Project: Great Wolf Lodge, Chesterton
Prepared by: Kathryn Lewis/ David Lewis
Approved by: Phil Bell
Date: 27/02/2020

1.0 Introduction

- 1.5 This Technical Note has been prepared in response to the comments from OCC and provides further detail public transport contributions, cycle network contributions, vehicle routeing and the effect of the development proposals on the signalised crossroads junction in Middleton Stoney.

Great Wolf,
Bicester
Figure 3.1 Alternative Vehicle
Routing
Not to Scale

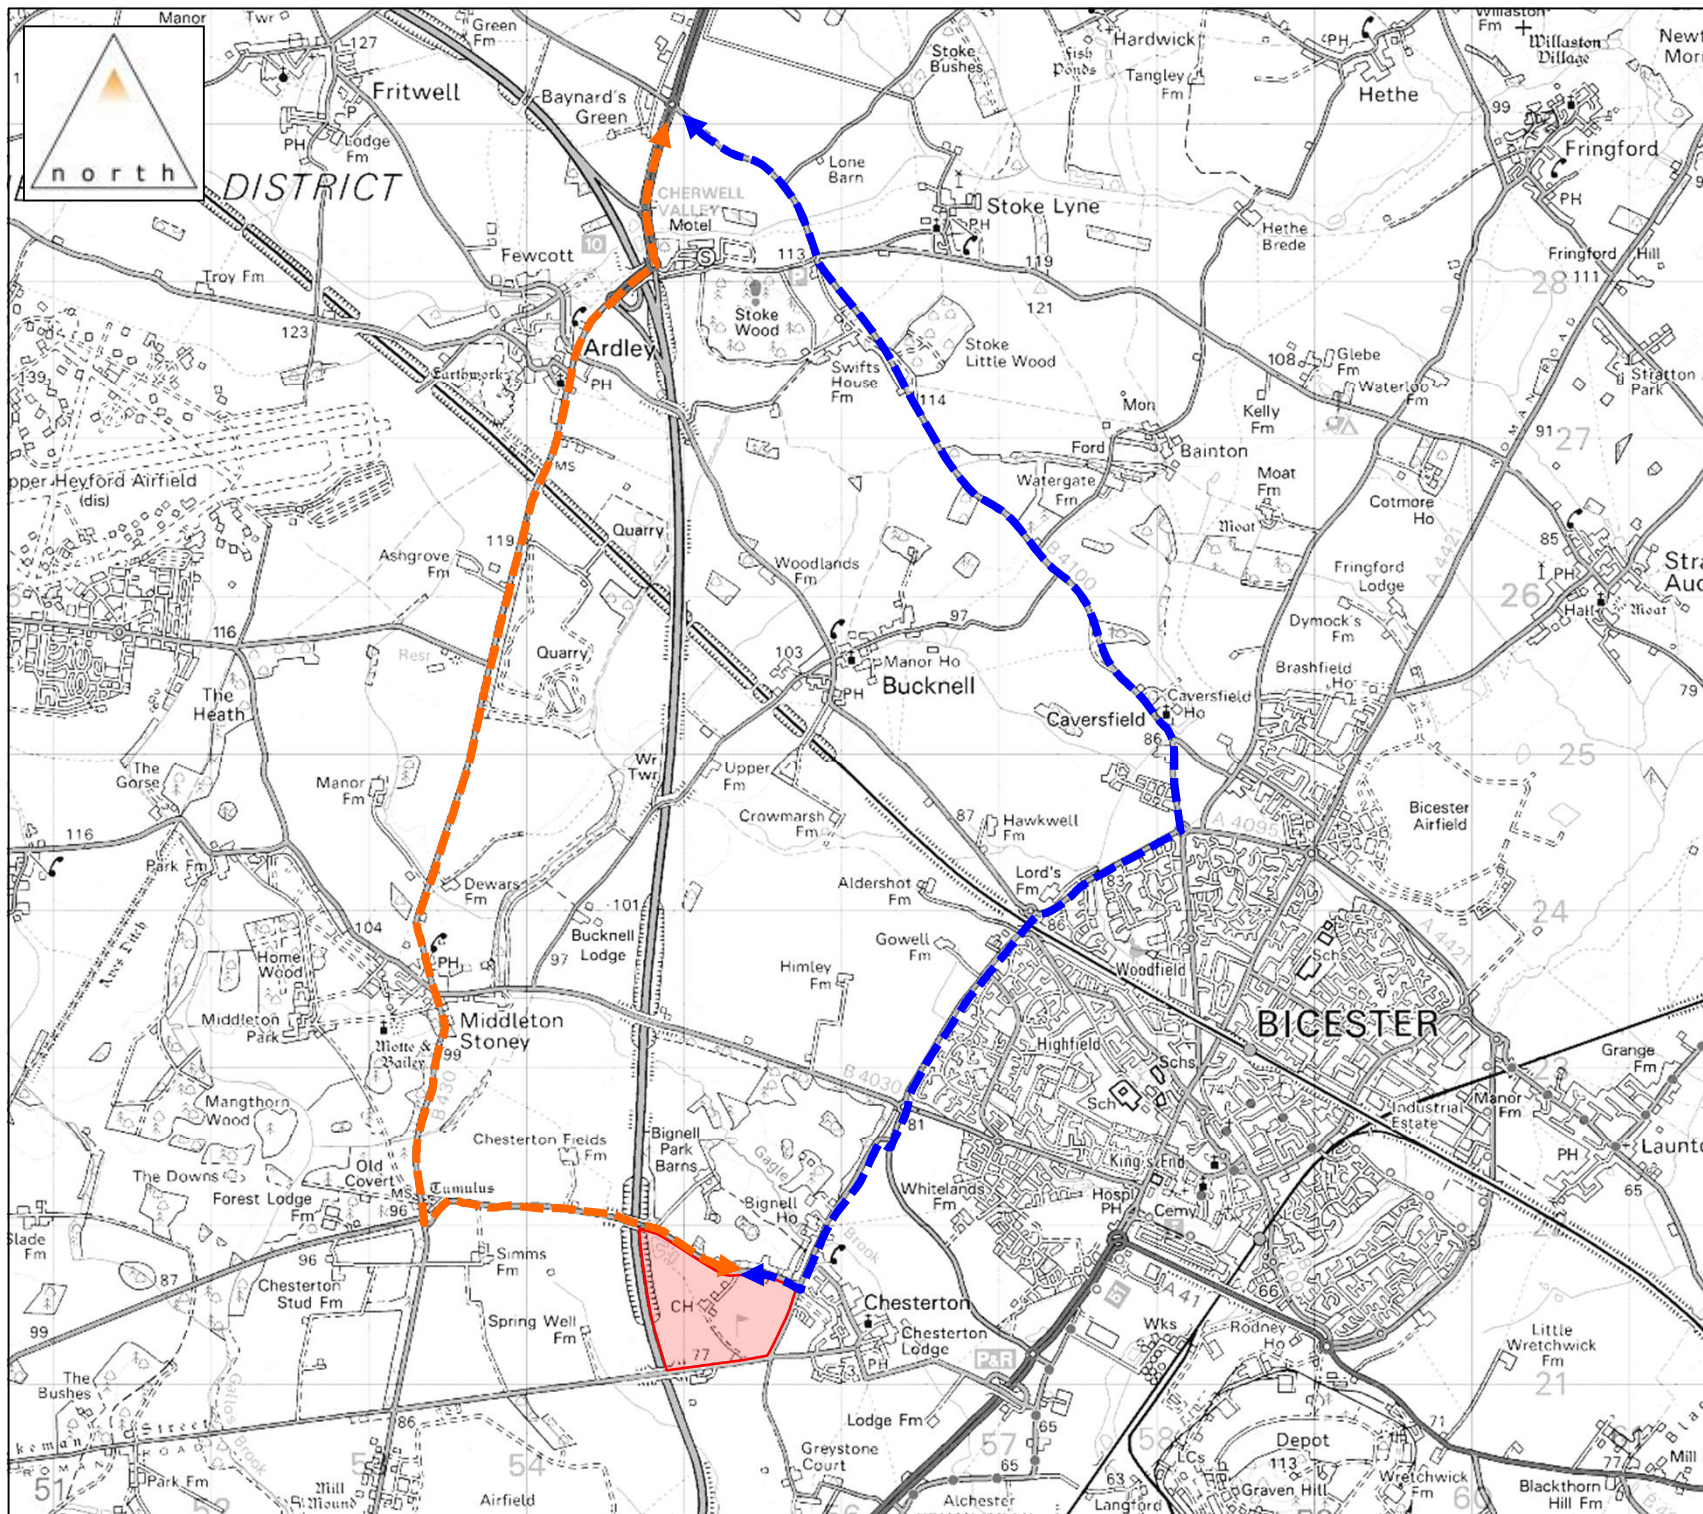
- 4.4 The analysis presented in the Transport Assessment assumed that all vehicles approach the site from the M40 (north) and A43 would route via the B430 to access the site. Consideration has been given to potential alternative routes for vehicles between the application site and the M40 (north) and A43. One potential signage strategy would be to direct drivers approaching from the A43, along the B4100 southbound towards Bicester and then along the A4095 towards the site. This is currently the signed route to Bicester from the A43 and does not result in a material change in journey time between the A43 and the site in comparison with the B430 route. The routeing considered in the Transport Assessment and the potential alternative route are presented at [Figure 3.1](#).

- 4.5 Utilising this alternative signage strategy could result in 16 fewer two-way vehicle trips routeing through the B430/B4030 junction during the morning peak hour, 21 fewer two-way vehicle trips during the evening peak. Table 4.1 summarises the change in vehicle trips should vehicles route via the B4100.

- 4.6 The analysis shows that this signage strategy could reduce vehicle movements on the B430 to 18 vehicles in the morning peak hour and 25 vehicles in the evening peak hour, equivalent to one vehicle every 3-4minutes and one vehicle every 2-3 minutes respectively. It is evident that the signage strategy could be developed in a manner to seek to minimise the number of trips associated with the development using the B430 and that this could be achieved via the strategic signage strategy for which the applicant has committed to provide a S106 contribution.

Drawing:
1803047-17

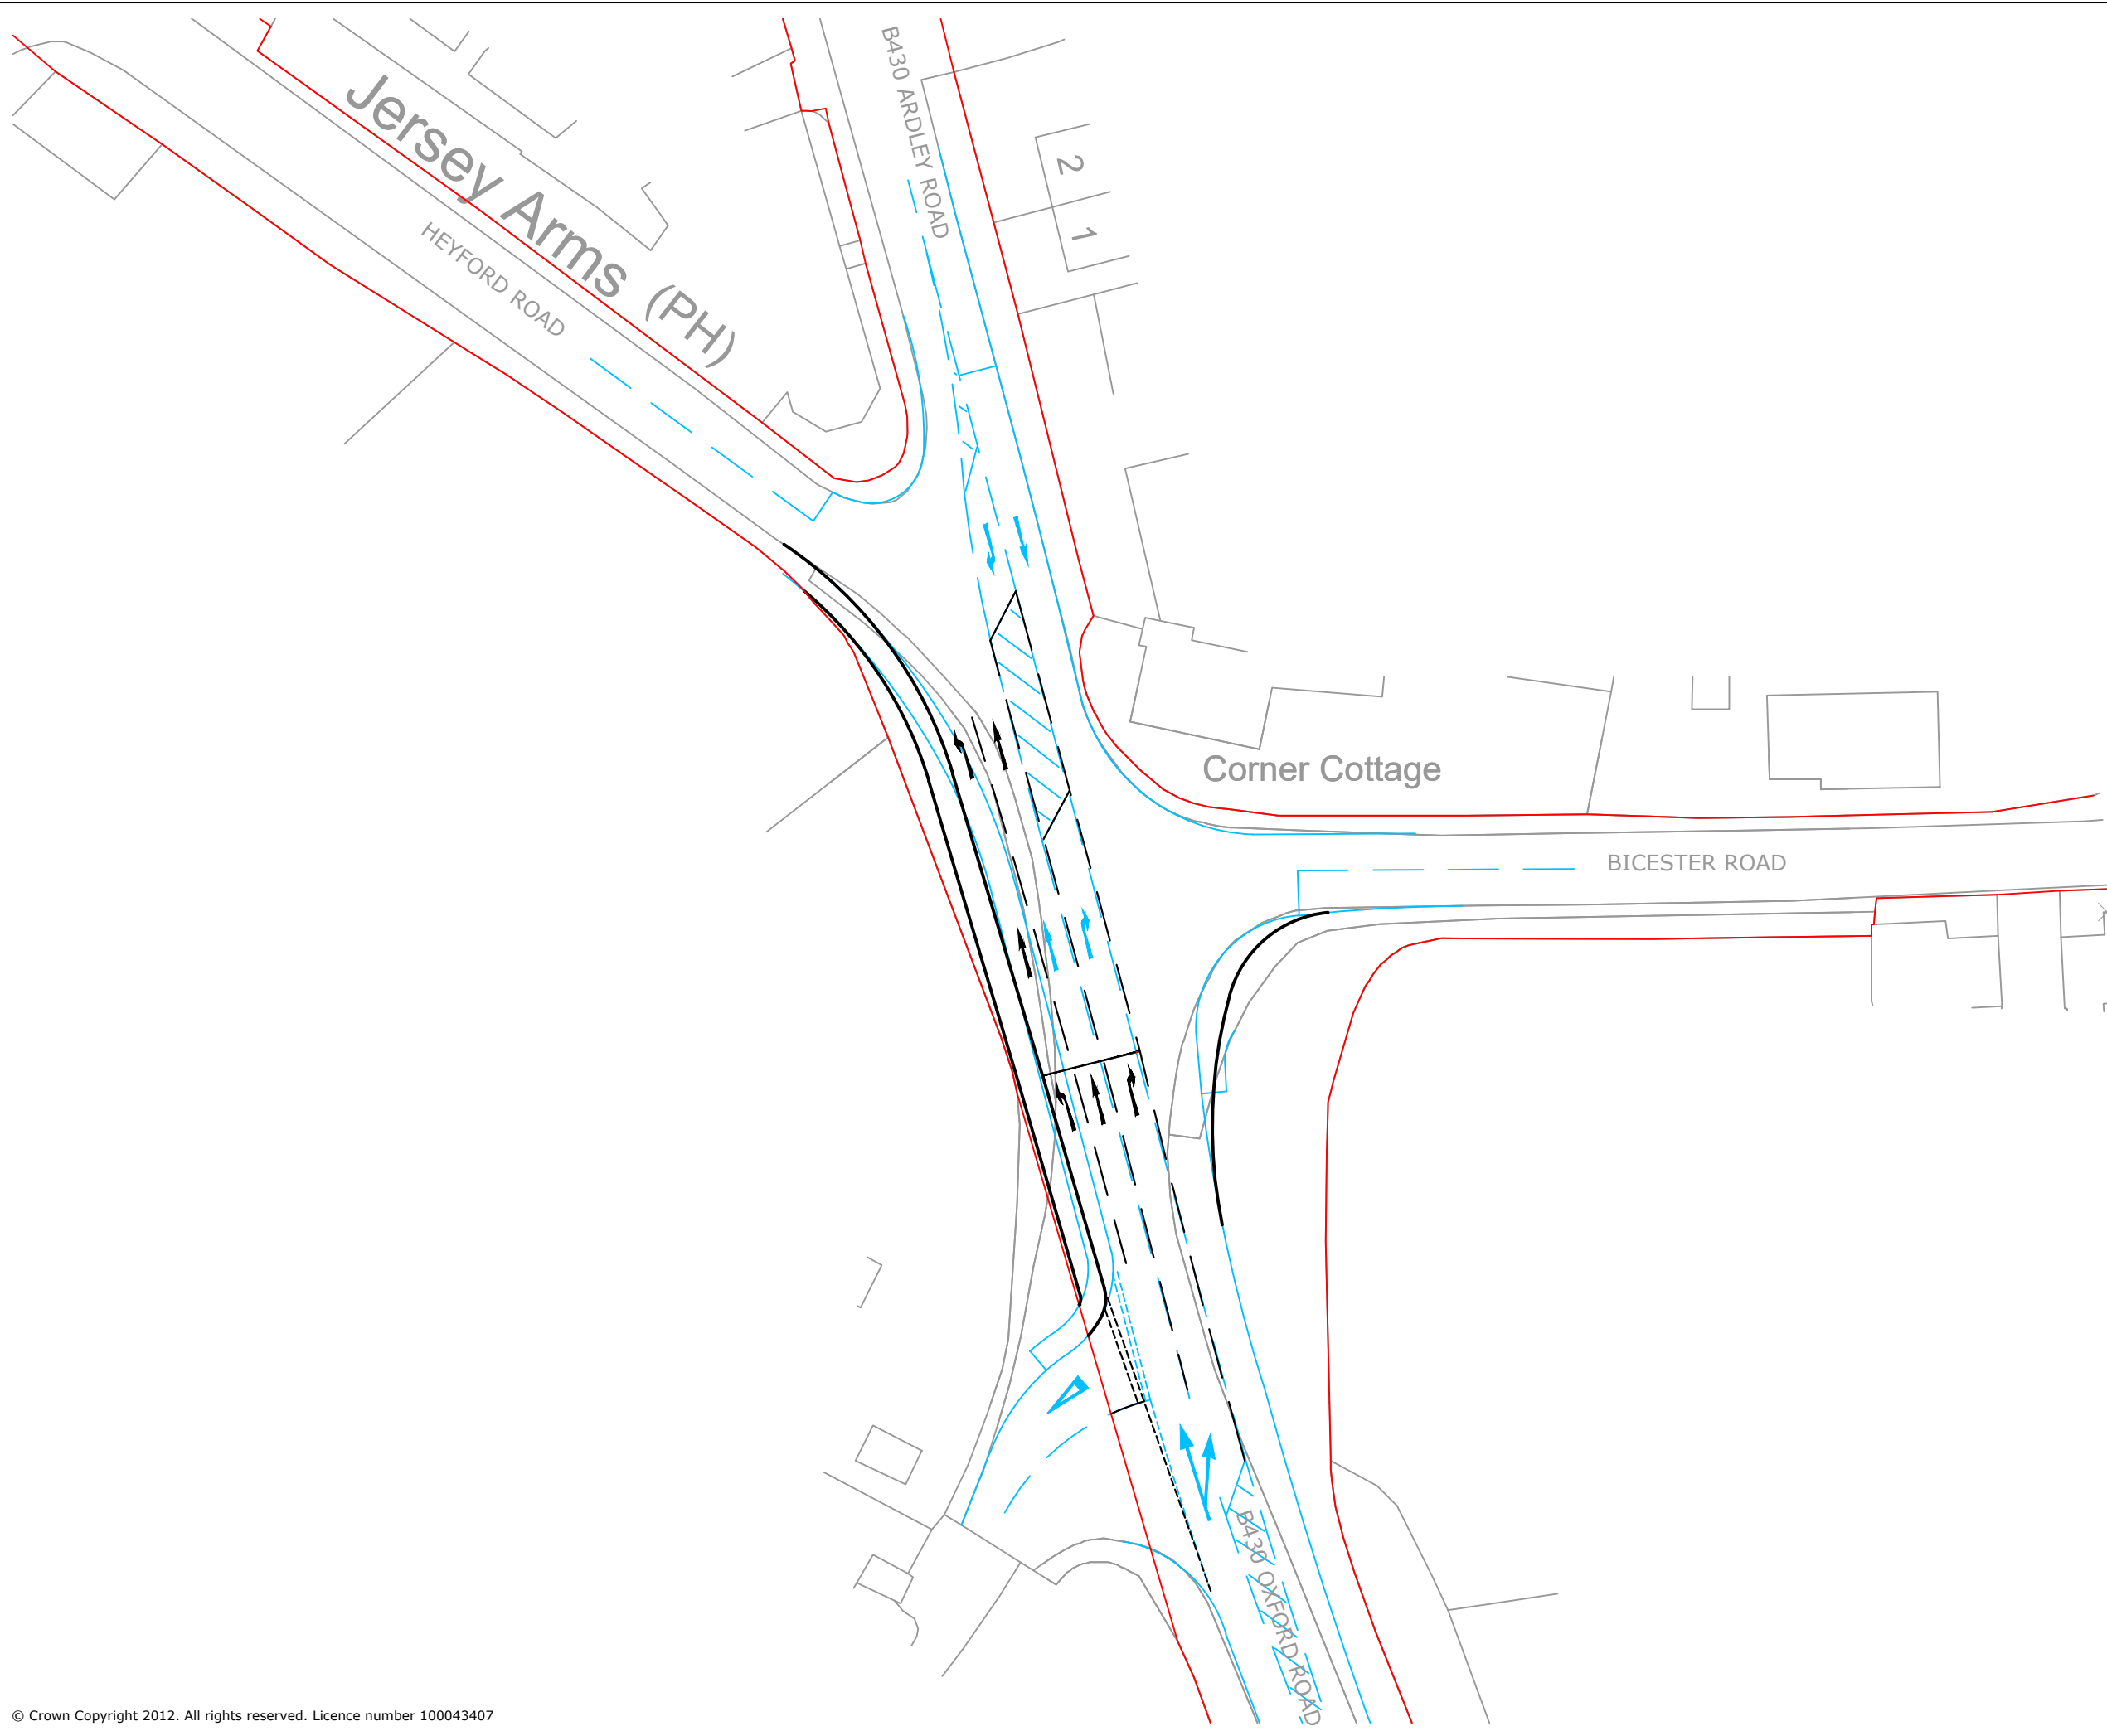
- 5.7 Consideration has given to highway works at the junction to mitigate the effect of the Great Wolf development and the approach of providing a highway mitigation scheme has been agreed in principle with OCC as a mechanism to remove the objection relating to the impact of the development at the junction.

- 5.9 A proposed scheme of works has been prepared and is presented at Drawing 1803047-17, attached at [Appendix B](#). The proposed works would be in addition to those consented as part of the Heyford Park Phase 1 and can be accommodated within the existing adopted highway at the junction. The works comprise the provision of an additional northbound dedicated left turn lane at the junction along with minor changes to the south-eastern kerbline and road markings. Full model output files are attached at [Appendix C](#).

- 5.11 Table 5.3 demonstrates that, whilst the junction will continue to operate in excess of its theoretical capacity during the weekday morning and evening peak periods, the junction would have improved operation in comparison with the analysis of the baseline scenario presented at Table 5.1. It is therefore concluded that the proposed highway works mitigate the impact of vehicles associated with the proposed development.
- 5.12 Table 5.4 summarises the operation of the B430/B4030 signalised crossroads in the 2026 scenario of the with the inclusion of traffic associated with both the Heyford Park Phase 1 and Phase 2 developments. The assessment includes consideration of vehicle trips associated with the Great Wolf development and the mitigation works shown at Drawing 1803047-17.

- 5.13 Table 5.4 demonstrates that, whilst the junction will continue to operate in excess of its theoretical capacity during the weekday morning and evening peak periods, the junction would have improved operation in comparison with the analysis of the baseline with Heyford Park Phase 2 scenario as presented at Table 5.2. It is therefore concluded that, in the scenario with the Heyford Park Phase 2 development include, the proposed highway works mitigate the impact of vehicles associated with the proposed development.

- ▶ Proposals for highway mitigation works at the B430/B4030 junction, as presented at Drawing 1803047-17 would mitigate the effect of the proposed development at his junction.
